Service Bulletin No: 52-006

Modification No: EC-14-0175

**CANOPY - GENERAL
INSPECTION FOR CORRECT INSTALLATION OF THE HINGE ATTACHMENT RIVNUTS****1. Planning Information****A. Effectivity**

Rivnuts - Inspection
Figure 1

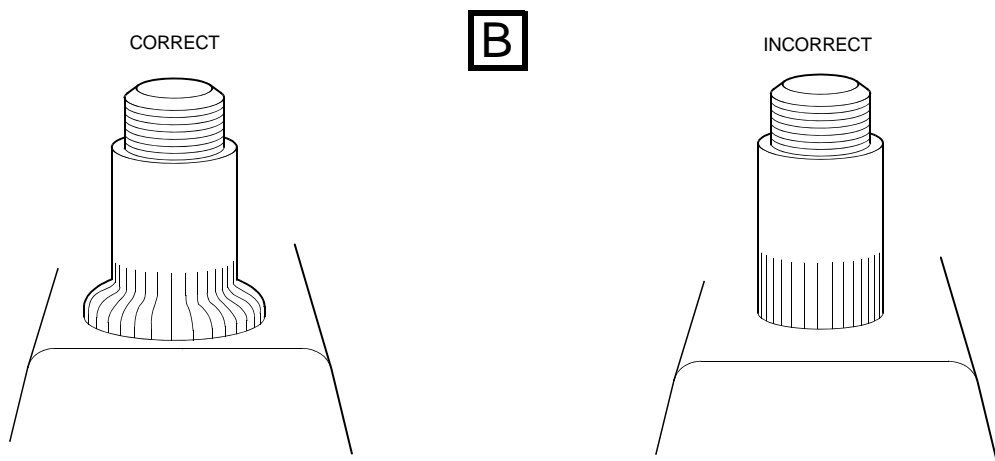
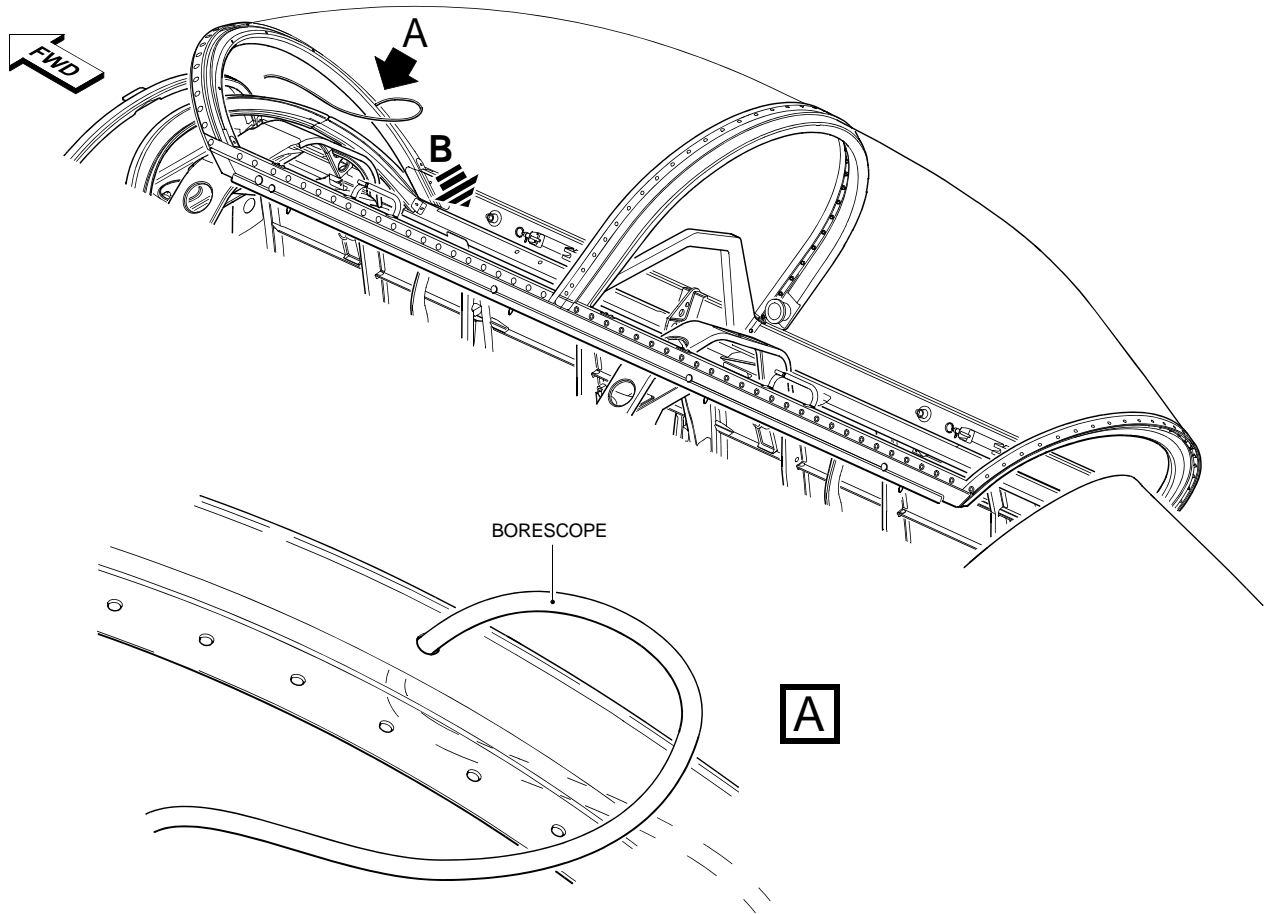
- (1) Put the flexible borescope through the tooling hole in the right side of the front frame of the canopy.
- (2) Push the flexible borescope into the right side frame until you can see the rivnuts.
- (3) Examine the first four hinge attachment-screw rivnuts (minimum).
- (4) If the rivnuts have a bulge they are correctly installed. Remove the borescope and do the re-identification procedure (Ref. Para. F.).
- (5) If the rivnuts are cylindrical with no bulge they are not correctly installed. Continue with the rivnut installation procedures.

- (1) Put the flexible borescope through the tooling hole in the right side of the front frame of the canopy.
- (2) Push the flexible borescope into the right side frame until you can see the rivnuts.
- (3) Examine the first four hinge attachment-screw rivnuts (minimum).
- (4) If the rivnuts have a bulge they are correctly installed. Remove the borescope and do the re-identification procedure (Ref. Para. 4.C.).
- (5) If the rivnuts are cylindrical with no bulge they are not correctly installed. Do the rivnut installation procedure for all the rivnuts for the hinge attachment screws (Ref. Para. 4.B.).

FIG. 2a
INSTALL TOOL

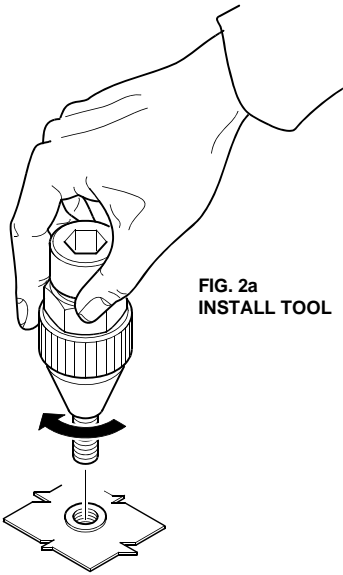
- (1) If the rivnuts are serviceable, use the Rivnut Handtool (P/N 513.53.09.029) and pull the rivnuts as follows (Ref. Fig. 2):
 - (a) Install the hand tool in the rivnut (Ref. Fig. 2a):
 - 1 Engage the threads of the pull-up stud (on the hand tool) with the threads of the installed rivnut.
 - 2 Turn the complete tool clockwise to fully install the pull up stud in the rivnut.
 - 3 Turn the anvil until it is tight against the head of the rivnut.

FIG. 2b
PULL RIVNUT

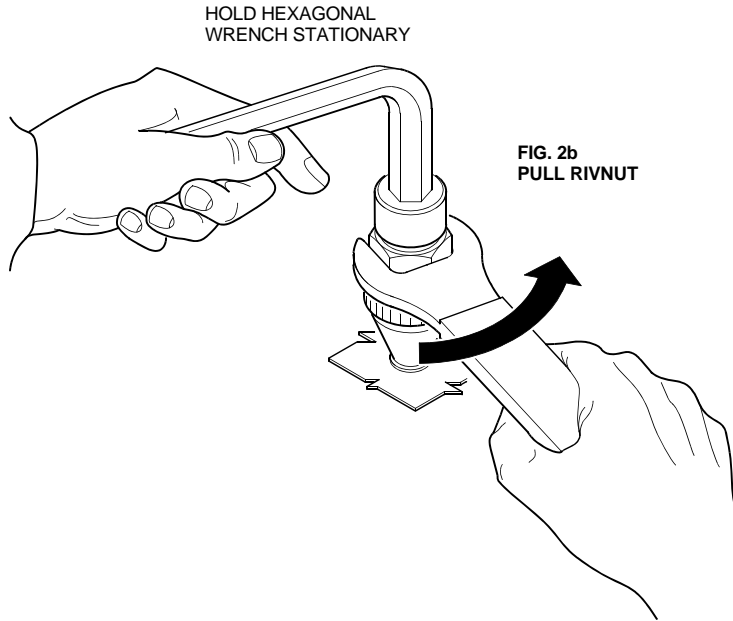
- (b) Pull the rivnut (Ref. Fig. 2b):

CAUTION: MAKE SURE YOU HOLD THE HAND TOOL PERPENDICULAR TO THE SURFACE OF THE CANOPY FRAME. YOU MUST NOT INSTALL THE RIVNUT AT AN ANGLE.

- 1 Insert the hexagonal wrench in the jackscrew of the hand tool.

CAUTION: DO NOT PERMIT THE HEXAGONAL WRENCH TO TURN WHEN YOU PULL THE RIVNUT. DAMAGE TO THE HANDTOOL CAN RESULT.

- 2 Hold the hexagonal wrench stationary.

CAUTION: DO NOT TURN THE LARGE HEXAGONAL NUT MORE THAN 3/4 OF A TURN. DAMAGE TO THE HANDTOOL CAN RESULT.

- 3 Use a wrench to turn the large hexagonal nut counter-clockwise for 3/4 of a turn.

NOTE: 3/4 of a turn is the maximum required to completely deform the sleeve of a rivnut that is not correctly installed.

FIG. 2c
LOOSEN TOOL

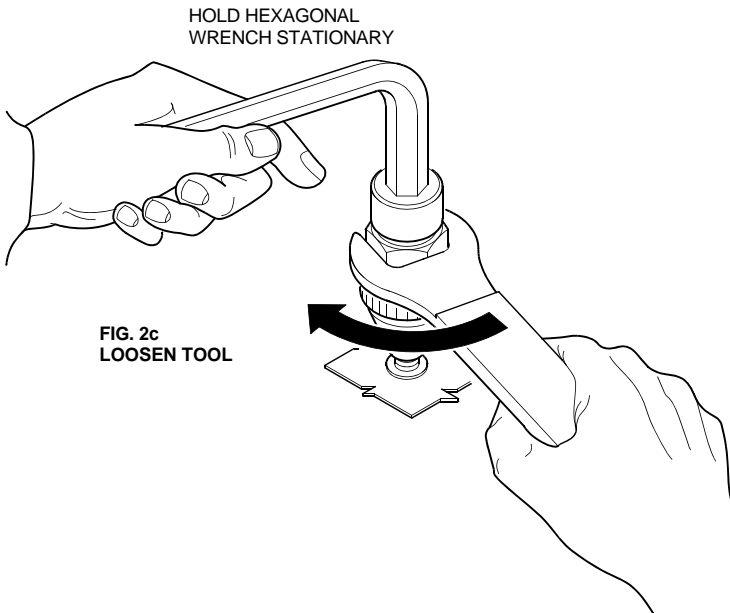
- (c) Loosen the hand tool (Ref. Fig. 2c):

- 1 Hold the hexagonal wrench stationary.

- 2 Break the large hexagonal nut loose with a clockwise turn.

- 3 Remove the two wrenches from the hand tool.

FIG. 2d
REMOVE TOOL

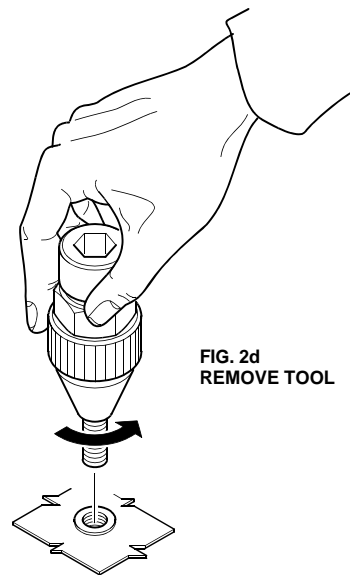
- (d) Remove the hand tool (Ref. Fig. 2d):

- 1 Turn the complete tool counter-clockwise to remove the pull-up stud from the rivnut.

- 2 Remove the hand tool.
